Access Compliance Report

Public Rights-of-Way

Intersection ID: 46809	Main Street: AZALEA_HILLS_DR	Cross Street: CLAUDE_FREEMAN_DR	Location: SW
ADA ID: 588514C964BA	Ramp Type: BlendTrans1	Initial Pass/Fail: Fail	Overall Compliance: No
		Severity Score: 21.25

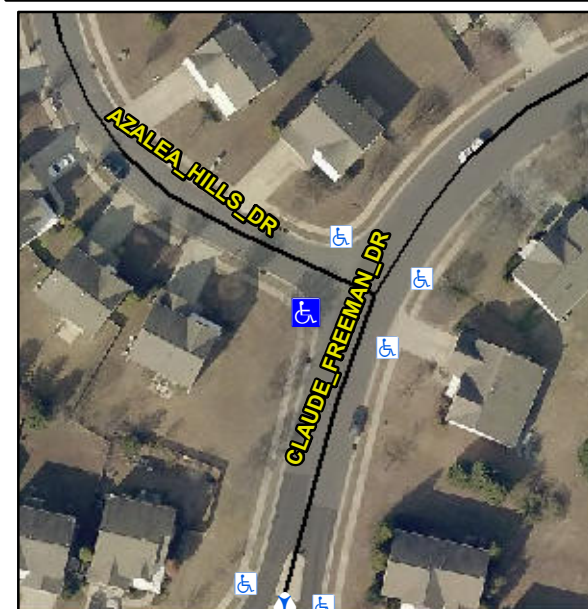
Not Found, R304.5.1, R304.5.3

Compliance	Description	Data	Compliance	Description	Data
N/A	Ramp Length (in)	46.5	Yes	BlendTrans Slope (%)	4.2
No	Ramp Width (in)	46.5	No	BlendTrans XSlope (%)	5.3
N/A	Flare Type LT	N/A	N/A	Flare Type RT	N/A
N/A	Flare Slope LT (%)	N/A	N/A	Flare Slope RT (%)	N/A
N/A	Flare Traversable LT?	N/A	N/A	Flare Traversable RT?	N/A
N/A	Landing Length (in)	N/A	N/A	DWS Provided?	N/A
N/A	Landing Width (in)	N/A	N/A	DWS Contrast?	N/A
N/A	Landing Slope (%)	N/A	N/A	DWS Length (in)	N/A
N/A	Landing X Slope (%)	N/A	N/A	DWS Full Width?	N/A
N/A	Landing Curb? (Y/N)	N/A	N/A	DWS Offset (in)	N/A
N/A	Shared Landing?	N/A			
N/A	Gutter Ponding?	N/A	N/A	Gutter Slope (%)	N/A
N/A	Gutter Lip Ht (in)	N/A	N/A	Gutter X Slope (%)	N/A
N/A	Painted X Walk1?	No	N/A	Painted X Walk2?	No
	X Walk 1 Direction	To SE		X Walk 2 Direction	To NE
	X Walk 1 Width (in)	N/A		X Walk 2 Width (in)	N/A
	X Walk 1 Slope (%)	0.1		X Walk 2 Slope (%)	0.5
	X Walk 1 X Slope (%)	2.9		X Walk 2 X Slope (%)	1.7

N/A	Ramp inside XWalk1?	N/A	N/A	Ramp inside XWalk2?	N/A
	Road Slope (%)	2.9		Clear Space?	N/A
	Road X Slope (%)	0.7	N/A	Clear Space to XWalk (in)	N/A
N/A	Any Obstructions?	N/A	N/A	Storm Grate/Utility Hazard?	N/A
	Obstruction Type			Storm Grate/Utility Type	
		N/A			N/A
			Yes	Surface Condition? (G/P)	Good
			No	Curb Slope (%)	5.3

Remove & Replace Curb Ramp With Two New Directional Ramps or Equivalent.
